# Gen 5 DD13 Turbo Oil Drain Tubes Cracking

## Description

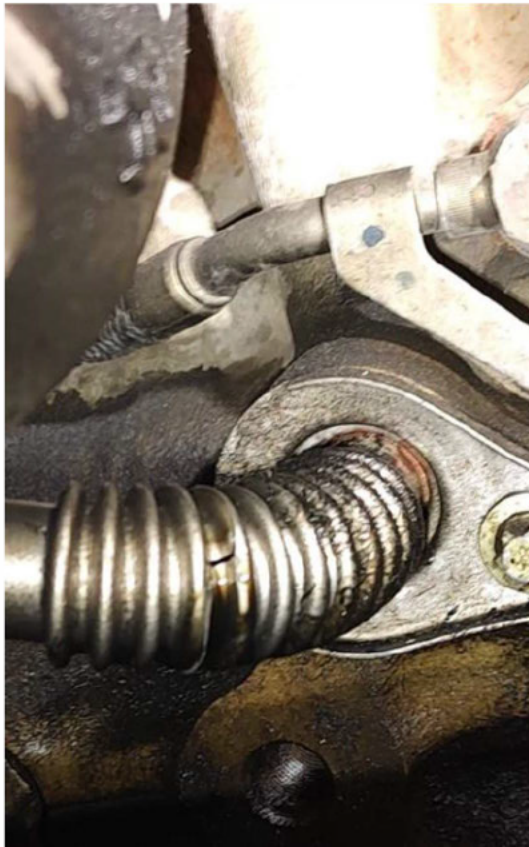
- Gen 5 DD13 turbo oil drain tubes are cracking and causing oil leaks. Based on returned material, missing turbo support bracket bolts appear to be a large contributing factor.

- **ICAs**
  - Workshop manual improvements – **First round published 07/30/24**. More improvements in process.
  - 24CSA-17 letter advising dealers to replace the turbo support brackets and hardware along with the broken tube. **Published 09/23/24**. Working to convert to a TS letter to incorporate into TechLane.

- **PCAs**
  - Assembly line installation sequence change to reduce stress on the tube. **Implemented 10/23/24**
  - Optimizing turbo bracket bolt tightening program to eliminate “re-hitting” an already tight bolt. **Implemented 12/04/2024**.

- Proposed 100% quality check of turbo bearing housing angle. **Evaluation ongoing**.
  - Proposed increased torque to turbo support bracket bolts. Current assembly line torque 25NM. Current service procedure is 30NM. **Implemented 1/24/25**.

- Proposed increased length to turbo support bracket bolts. **Change in review**.
  - Eliminate supplier quality defects on turbo support brackets as seen in field returns. **Discussion ongoing with supplier**.

- Replace the turbo oil drain tube. Check the turbo mounting brackets for cracks or loose/missing bolts. Follow 24CSA-17.
